AREVA Enrichment Services LLC
Eagle Rock Enrichment Facility
NRC Docket No: 70-7015

Subject: Notice of Organization Change for the Eagle Rock Enrichment Facility License Application

AES Organization Change

Marked-up Pages for the Safety Analysis Report and the Quality Assurance Program Description

Figure 1-2 **Rev. 2**
Engineering, Procurement and
Construction (EPC) Organizational Chart
EAGLE ROCK ENRICHMENT FACILITY
QUALITY ASSURANCE PROGRAM DESCRIPTION

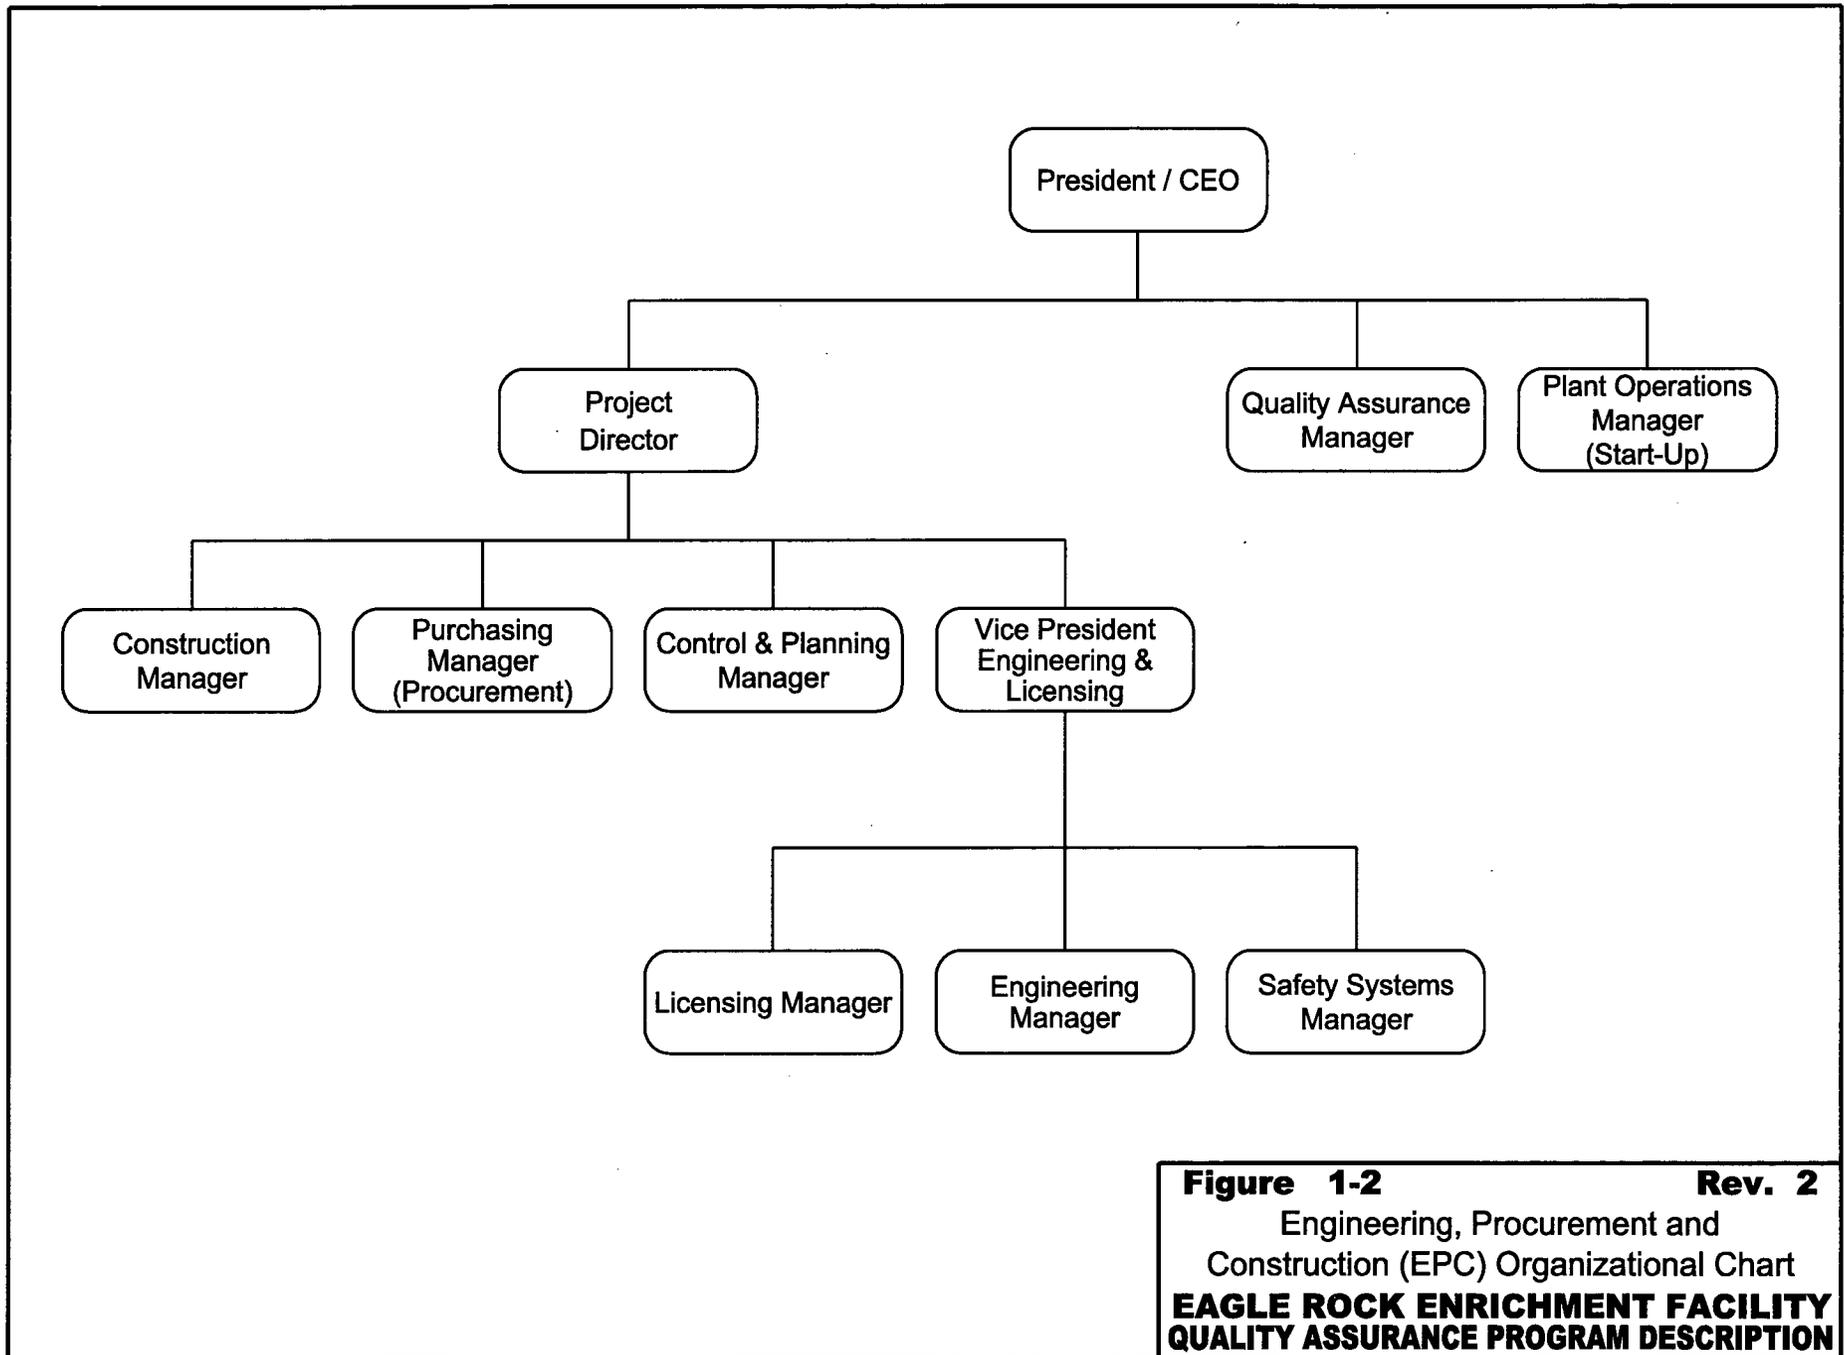
- 1.1.1 AREVA Enrichment Services, LLC (AES) maintains overall responsibility for design, refurbishment, construction, start-up, operations, and decommissioning of the Eagle Rock Enrichment Facility.
- 1.1.2 Figure 1-1 of this QAPD shows the site management operating organization for the Eagle Rock Enrichment Facility (EREF).
- 1.1.3 Figure 1-2 of the QAPD shows the engineering, procurement, construction, and initial start-up organization of the EREF.

- 1.2.3 The AES President has designated the ~~Vice President Engineering and Engineering, Procurement and Construction (EPC) Project Manager~~ the responsibility for design, construction, procurement, and initial start-up for the Eagle Rock Enrichment Facility. The QAPD is binding on all AES and contractor personnel involved with the Eagle Rock Enrichment Facility.

- 1.2.4 ~~A Deputy EPC Project Manager may assist the EPC Project Manager in planning and implementation of EPC activities.~~
- 1.2.5 The AES President has designated the Plant Manager the responsibility for operation, maintenance, and associated support activities for the Eagle Rock Enrichment Facility.

The AES President has designated the Plant Operations Manager the responsibility for initial start-up for the EREF.
